APPLICATION NO.	FILING DATE	FIRST NAMED INVENTOR	ATTORNEY DOCKET NO.	CONFIRMATION NO.
10/801,858	03/17/2004	Hermann Baumann	080443.53218US	1965

Office Action Summary

2. Applicant is required to insert the following paragraph on Page 1, after the title of "Arrangement for an Exhaust Gas Turbocharger With a Carrier Housing":

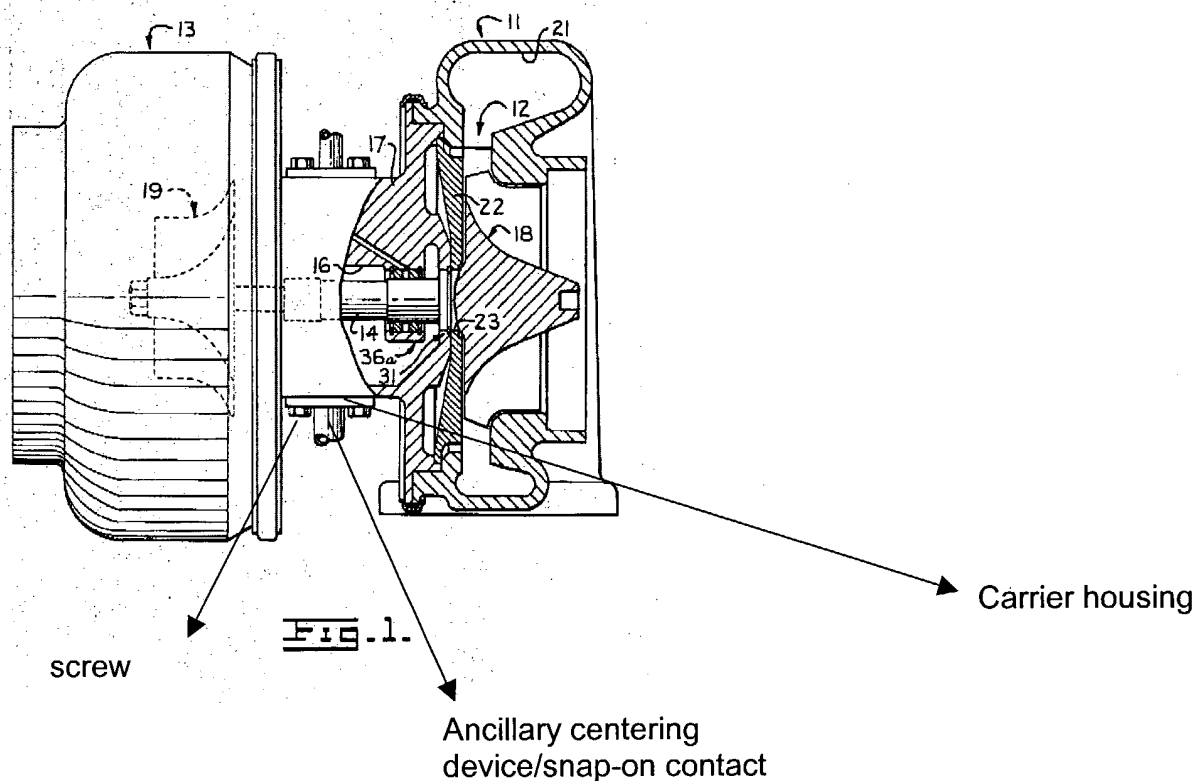
Claims 1, 3-5, 9, and 11-13 are rejected under 35 U.S.C. 102(b) as being anticipated by Miller (Patent Number 3,565,497).

Miller discloses an arrangement for an exhaust gas turbocharger with a carrier housing (Not Numbered), the exhaust gas turbocharger comprising:

a compressor wheel (19),

a turbine wheel (18),

a bearing housing (17), and
a shaft (14) adapted to connect the compressor wheel (19) and the turbine wheel (18),

wherein the exhaust gas turbo charger is attached to the bearing housing (17) with the carrier housing (Not Numbered) by way of a fastening element, which is oriented in a direction perpendicular to an axis of rotation of the shaft (14) (See attached Figure 1);

wherein an ancillary centering device for orientation of the exhaust gas turbocharger on the carrier housing is provided on the bearing housing (See attached Figure 1);

wherein the ancillary centering device is in the form of a snap-on contact (See attached Figure 1);

wherein, by way of the snap-on contact, lubricant is conducted out of the bearing housing and into the carrier housing (See attached Figure 1, Column 3, lines 23-28).

Miller discloses the invention as recited in the rejection of claim 1, and further discloses the fastening element is in the form of screws (Not Numbered, See attached Figure 1); an ancillary centering device for orientation of the exhaust gas turbocharger on the carrier housing being provided on the bearing housing (17); the ancillary centering device being in the form of a snap-on contact; and by way of the snap-on contact, lubricant being conducted out of the bearing housing and into the carrier housing See attached Figure 1, Column 3, lines 23-28).

However, Miller fails to disclose screw heads of the screws being arranged within a diameter of the bearing housing.
